Appendix 1:

Information requested under Clause 23 of First Schedule of the Resource Management Act 1991

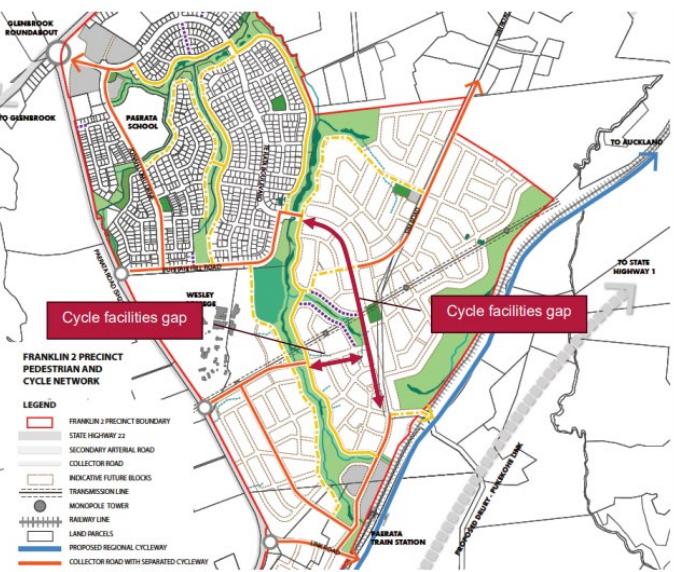
T9	Transport - cycling	Please provide an evaluation of the extent to which the proposed cycle network provides a well-connected internal street network for cycling that connects to public transport and the RTN station in particular.	Franklin 2 Precinct Plan 2 Road Hierarchy, Pedestrian and Cycle Network indicates that Boulevard Road and part of the east/west Collector Road will not have cycle facilities along the central section. This is confirmed by the Indicative Pedestrian and Cycle Network Plan contained in the Urban Design Plan Set. In our view this creates potential gaps in the cycle network as illustrated below.

#	Information category	Further information requested	Reasons for request
			 <p>An alternative route is provided via a Riparian Reserve Separated Cycleway, however in our view this creates a less direct, and potentially less attractive, route for cyclists. In our view it is important to maximise the cycle catchment for the Paerātā train station and to provide alternatives to, and reduce dependency on, private motor vehicles.</p>
T10	Transport - cycling	<p>Two design options are proposed for active modes along the reserve and includes a 'shared pedestrian/cycleway' and a 'riparian reserve separated cycleway.' Please provide details on their design and function,</p>	<p>This is to better understand the intended purpose, functionality, and design of different types of active mode paths and how they will link into the adjacent network.</p>

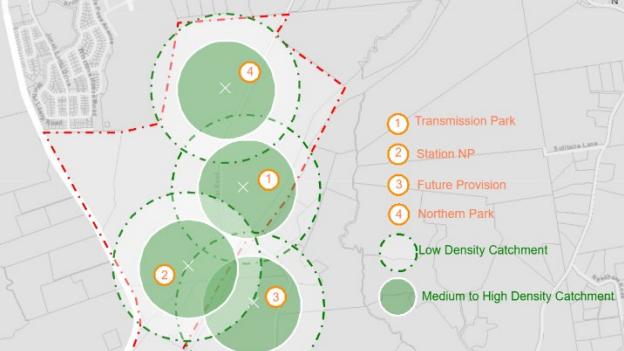
Economics – Derek Foy, Formative Ltd			
E1	Economics - population projections	Please update the Economics assessment to refer to the Auckland Growth Scenario v1.1 projections.	<p>The Economics assessment (Appendix 11) identifies the existence of Auckland Council's "ACMar23" projections, but applies the latest Statistics NZ population projections because (it states) the ACMar23 projections are not available at a detailed spatial level, such as Property Economics required for their assessment. The Economics assessment goes on to state that "unless a more detailed breakdown of ACMar23 projections that align with the spatial specifically required for the identified core catchments is made available, the Stats NZ projections remain the most appropriate data source for the economic assessment.</p> <p>In October 2024 Auckland Council published a more detailed breakdown of the ACMar23 projections. The ACMar23 projections are now referred to as "Auckland Growth Scenario" (AGS23), and published projections include household, population and employment projections over a 30-year period from 2022 to 2052. Council bases its strategic planning (including NPS-UD HBA and Future Development Strategy) on</p>
